Report of the Camp Lejeune Water-Modeling Expert Panel

Expert Peer Review Panel Evaluating ATSDR's Water-Modeling Activities in Support of the Current Study of Childhood Birth Defects and Cancer at U.S. Marine Corps Base Camp Lejeune, North Carolina

Analyses of Groundwater Resources and Present-Day (2004) Water-Distribution Systems,
March 28–29, 2005

Figure 2. Present-day (2004) water-distribution systems serving Hadnot Point, Holcomb Boulevard, and Tarawa Terrace areas of U.S. Marine Corps Base, Camp Lejeune, North Carolina.

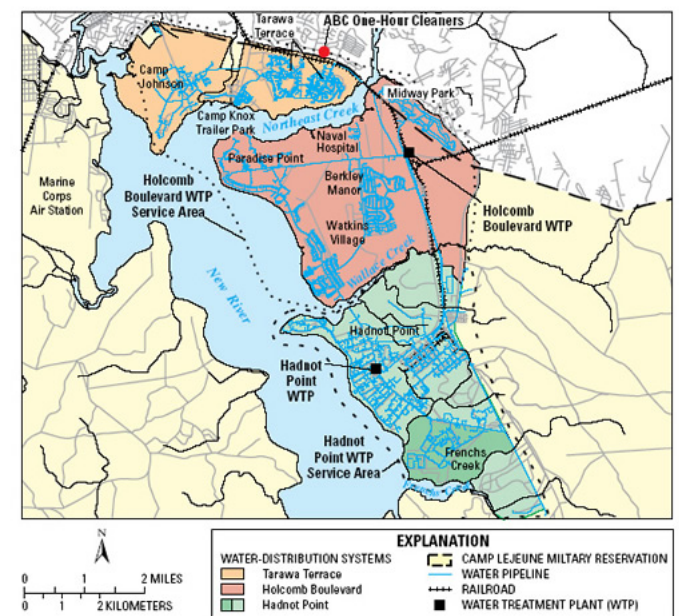
In terms of housing, the Hadnot Point service area (Figure 2) contains one family housing area and multiple bachelor housing areas; the remaining areas are primarily industrial use. Holcomb Blvd., however, has three housing areas; Tarawa Terrace is nearly 100% family housing, except for a few shopping centers.
